**AMENDMENT 4**

**Invitation for Bid (IFB)  
UOG IFB No. B23-05**

**“HYFLEX CABLING”**

**QUESTION & ANSWER SHEET NO. 2**

# HSS Power Plans

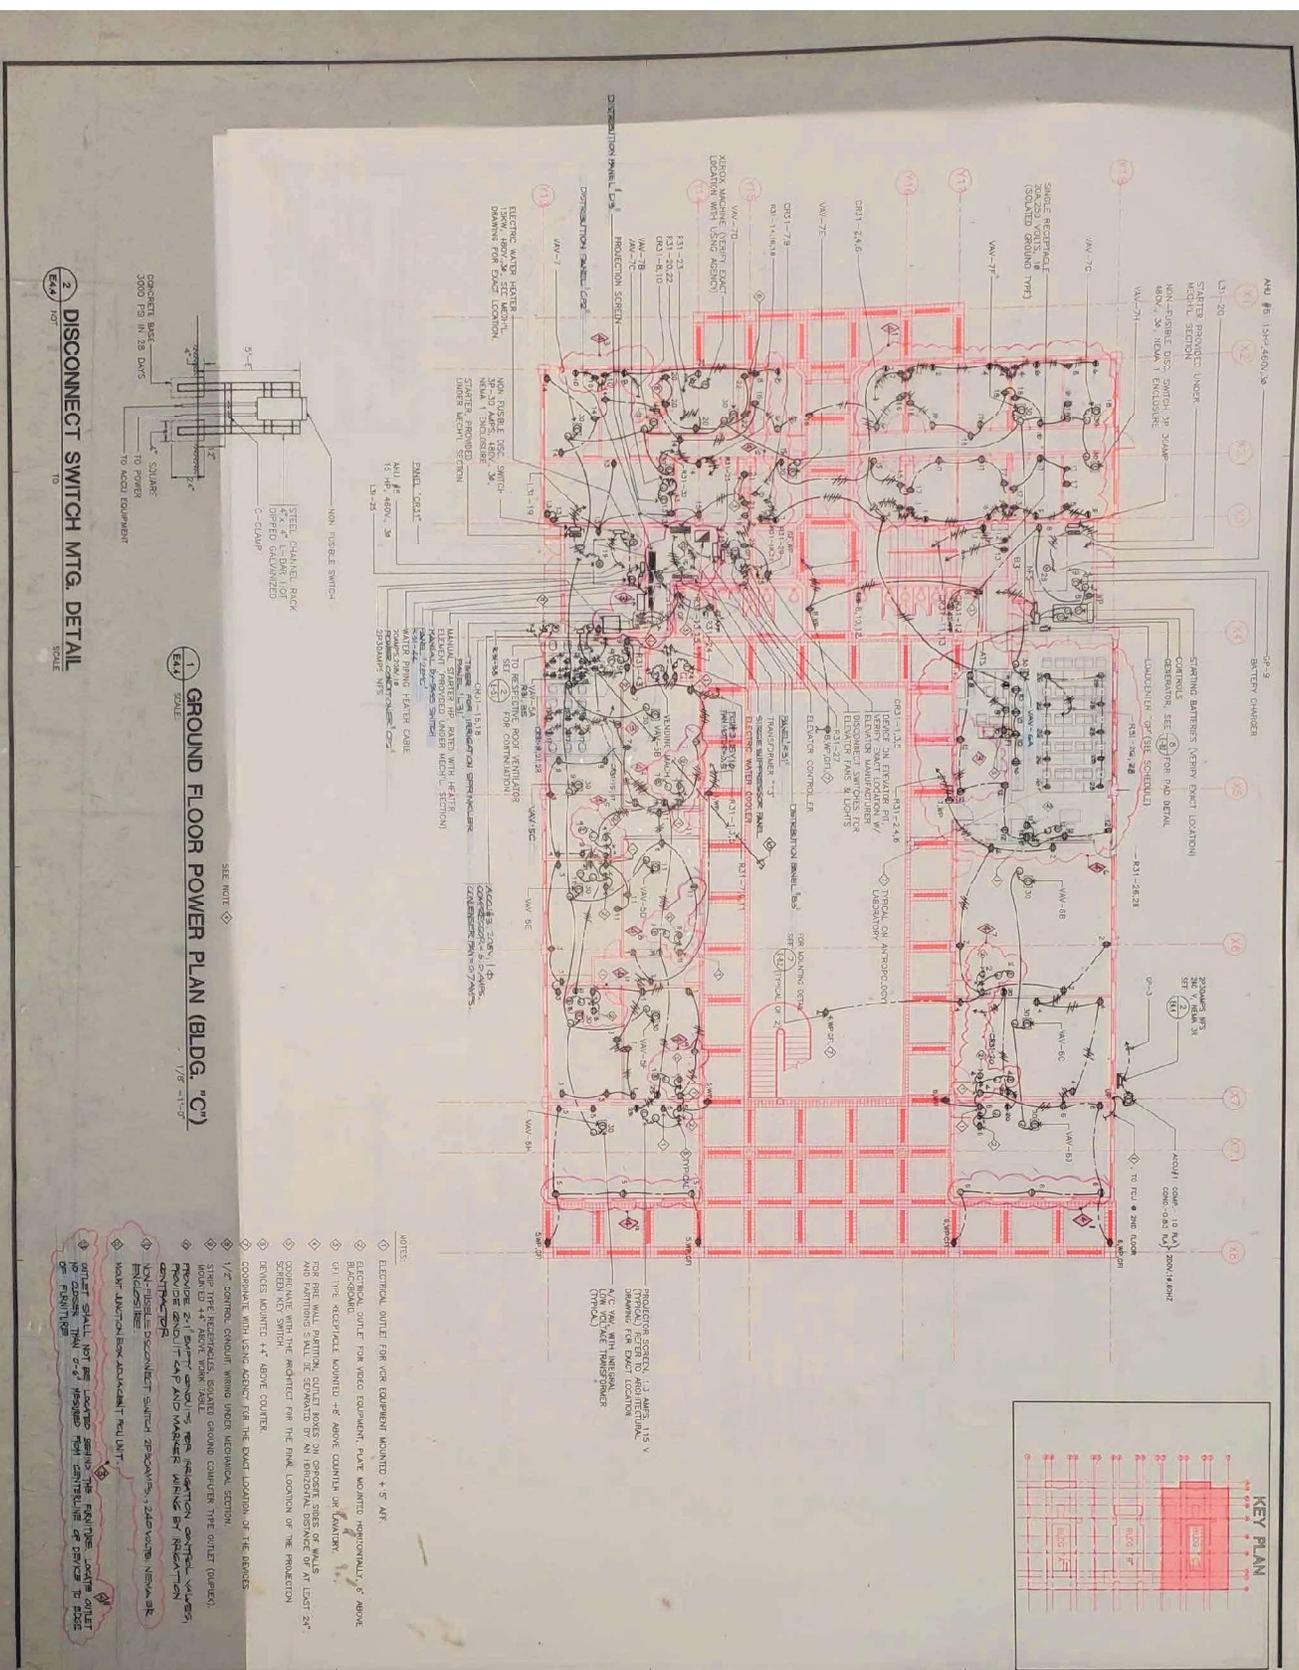
**Question 1:** Thank you for the Communication Plans. Would UOG be able to provide Electrical Plans of both buildings, which should show the conduit paths?

**Answer:** UOG confirms: See attached EC and HSS Power plans.
